Main Street Advisory Board

Agenda – March 2, 2023, 5:00 p.m.

STAFF REPORT

CASE NUMBER: COA-0006-2023
APPLICANT: Cody Durden
REQUEST: Reestablish storefront window, add screening for outdoor smoker
LOCATION: 805 Commerce Street; Parcel No. 0P0060 086000

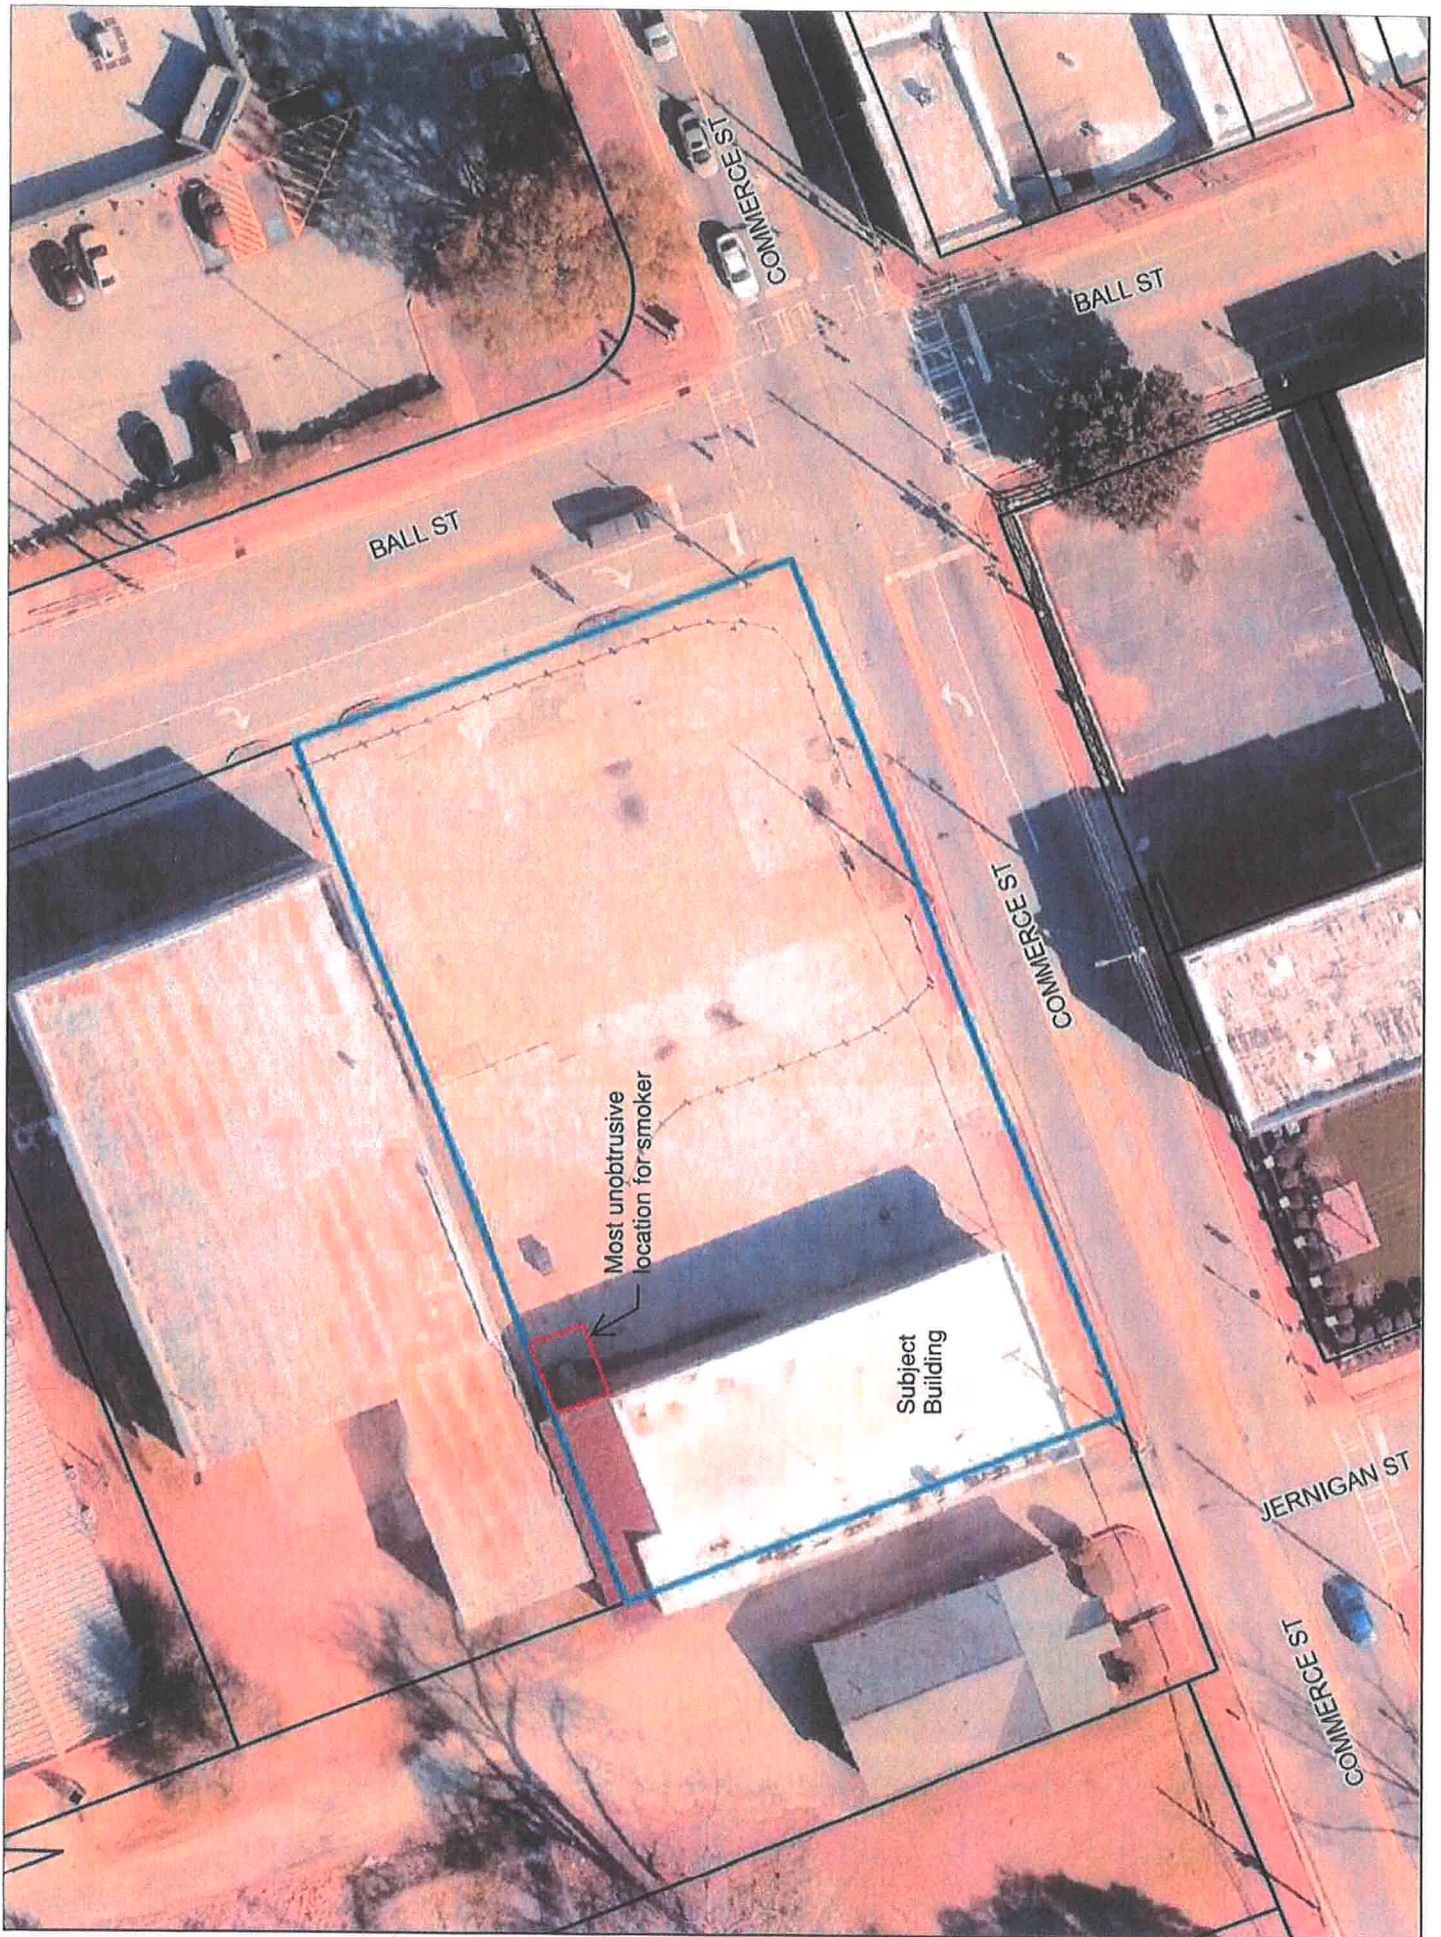
Ms. Hartley advised the applicant proposes to re-establish a storefront window on the Commerce Street elevation of the existing building and paint existing aluminum window/door frames black. The new window will have a black aluminum frame. The window will not extend the full height of the original window opening. The applicant proposes to fill the upper portion of the window opening with wood. A sign will be installed in the closed-in window opening on the left side of the façade. An outdoor smoker will be part of the business occupying the building. The applicant states the Department of Agriculture requires the smoker to be screened. He is also requesting the Board recommend an appropriate location for the smoker.

Ms. Hartley advised the staff comments in the report are as follows: The building was constructed in 1956, so an aluminum storefront window system is appropriate to the age of the building. Reestablishing a window is governed by the design guidelines for commercial rehabilitation on pages 16 through 19 of the *Design Guidelines for the Downtown Development Overlay District*. Per the guidelines, the window should extend the full height of the original opening. If the interior ceiling structure extends below the existing window opening, and is not planned to be modified, then the aluminum storefront system should extend the full height of the original window opening with either solid panels or opaque glass covering the interior structure. A wood panel separate from the storefront system is not appropriate. The solid/opaque portion of the storefront system should be no than 20% of the overall height of the opening. The remaining portion of the system should incorporate clear, nonreflective glass. Placement and screening of the proposed smoker is governed by the design guidelines for commercial site and setting guidelines on pages 36-39. The smoker should be located as unobtrusively as possible and screened with a wood fence. The parking lot side of the building appears to be the only reasonable location for the smoker. The corner near the rear of the building would be the most unobtrusive location.

STAFF COMMENTS: The building was constructed in 1956, so an aluminum storefront window system is appropriate to the age of the building. Reestablishing a window is governed by the design guidelines for commercial rehabilitation on pages 16 through 19 of the *Design Guidelines for the Downtown Development Overlay District*. Per the guidelines, the window should extend the full height of the original opening. If the interior ceiling structure extends below the existing window opening, and is not planned to be modified, then the aluminum storefront system should extend the full height of the original window opening with either solid panels or opaque glass covering the interior structure. A wood panel separate from the storefront system is not appropriate. The solid/opaque portion of the storefront system should be no than 20% of the overall height of the opening. The remaining portion of the system should incorporate clear, nonreflective glass.

Paint aluminum frame black

Wood panel above new window

Install new storefront
window here

STAFF RECOMMENDATION: Approval as described in the staff comments.

LEFT SIDE ELEVATION

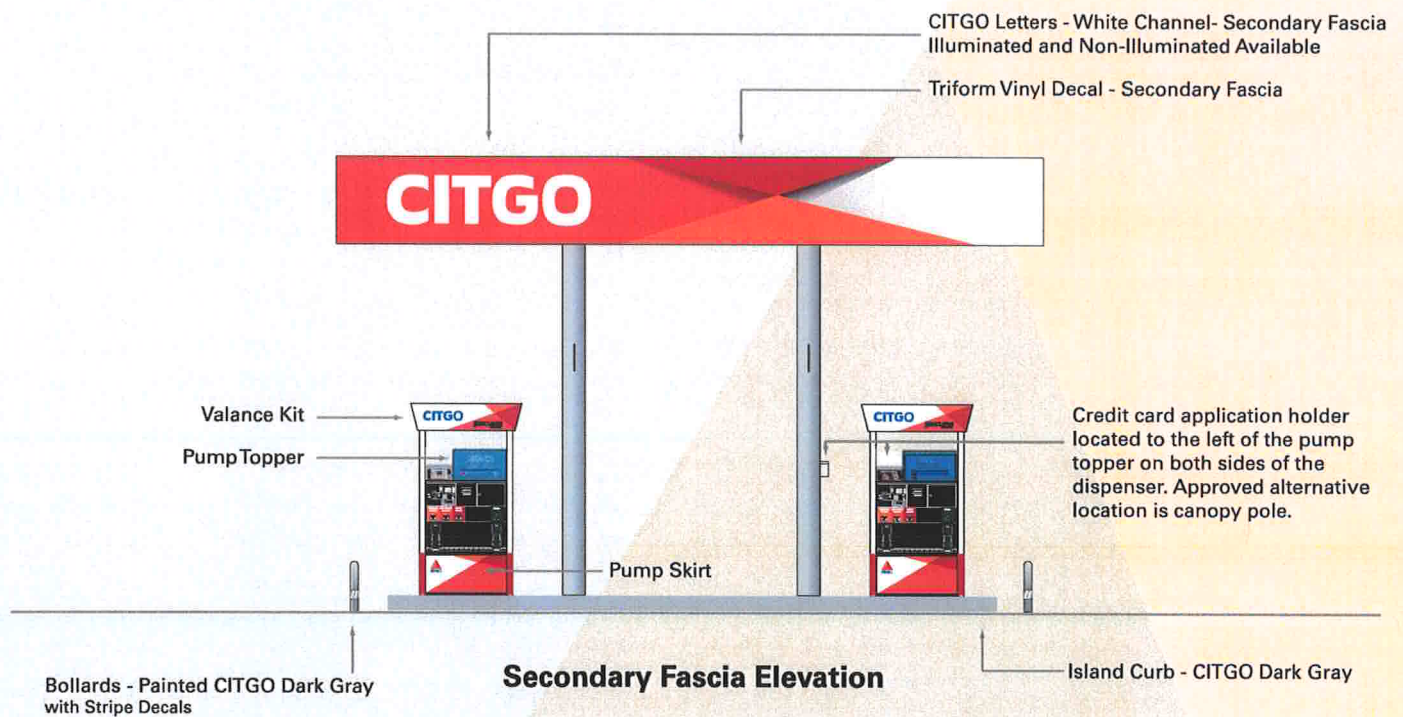
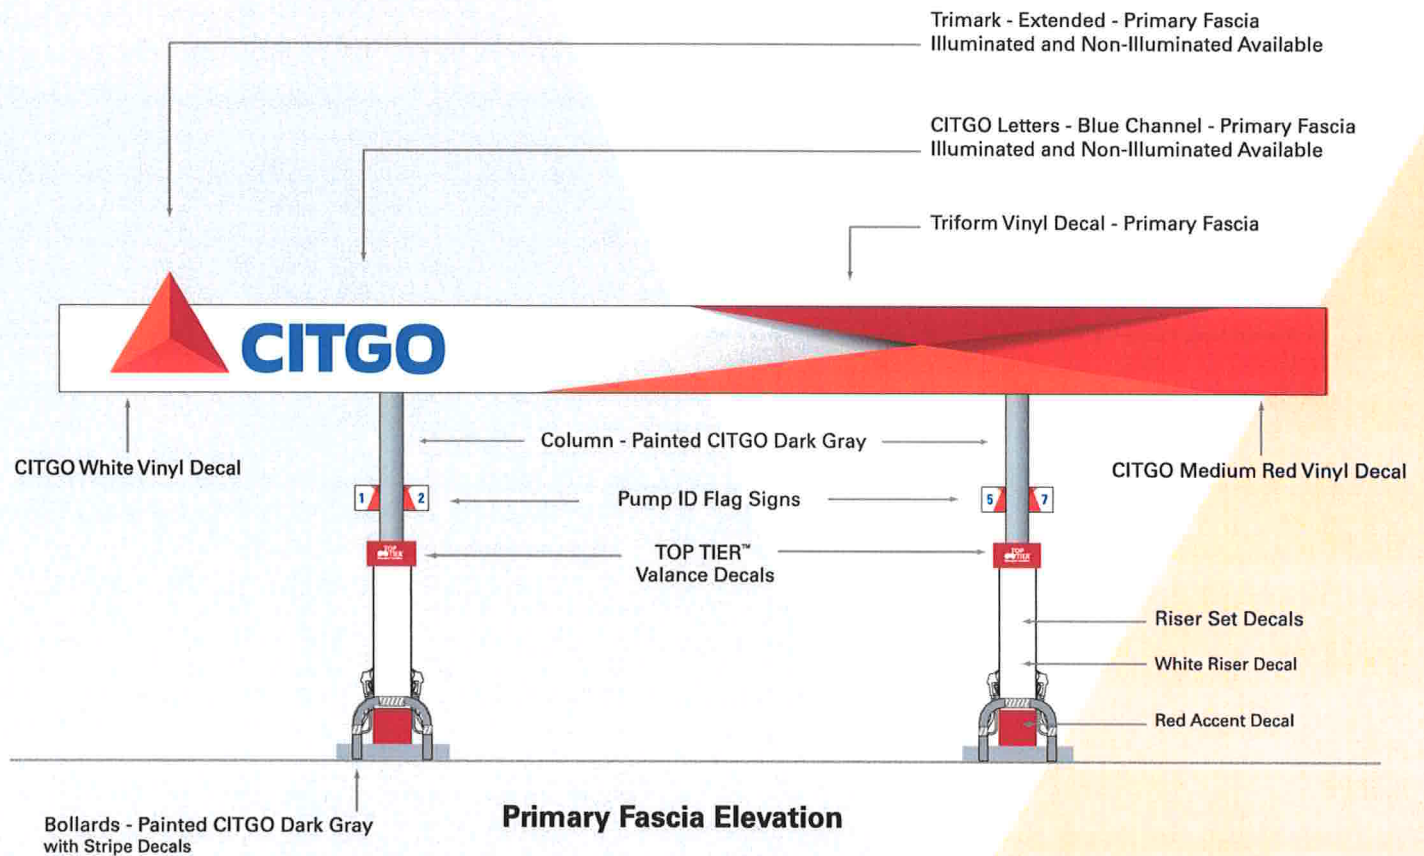
APPLICANT'S REQUEST: The applicant proposes to add brick veneer to the front and sides of the existing convenience store building (two options offered), paint the side and rear walls an approved color, and paint the fascia of the building and fuel canopy red, white, and blue stripes. The owner has indicated the fuel element will be branded either as Citgo or Marathon.

PAINT THIS PORTION OF FACILITY TO MATCH STUCCO ON SIDES OF FACILITY.

View of site and oak tree in right-of-way

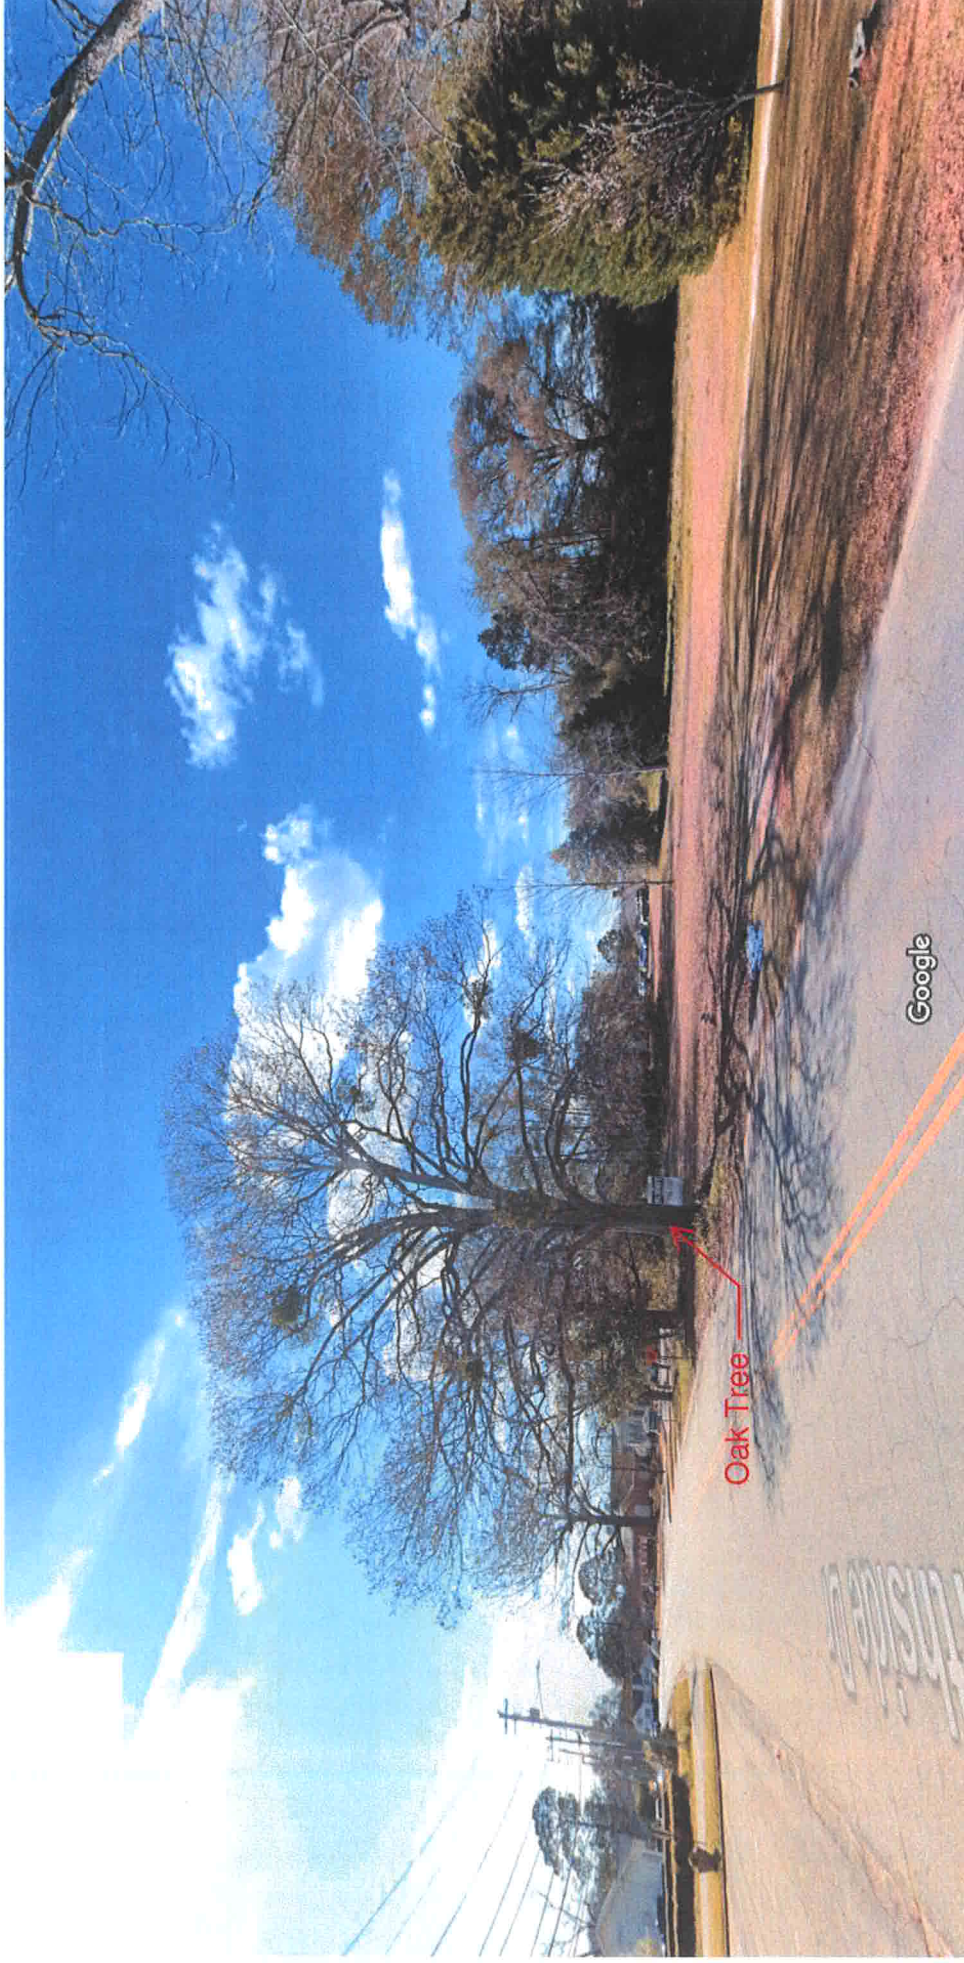
The proposal appears to comply with design guidelines regarding placement, scale, form, openings, materials and details. Walls and fences are not proposed at this time. Modern features (mechanical systems, utility meters, etc.) should be located to limit negative visual impact. Staff will verify during the permit review process that modern features are properly located. Parking is located on the sides of the building. Parking should be partially screened per the Walls and Fences guideline.

1. Staff shall ensure the placement of modern features and screening of parking are consistent with applicable design guidelines.
2. Applicant shall consult with staff and a certified arborist regarding the health and survival of the large oak tree located in the public right-of-way and provide a report to staff.
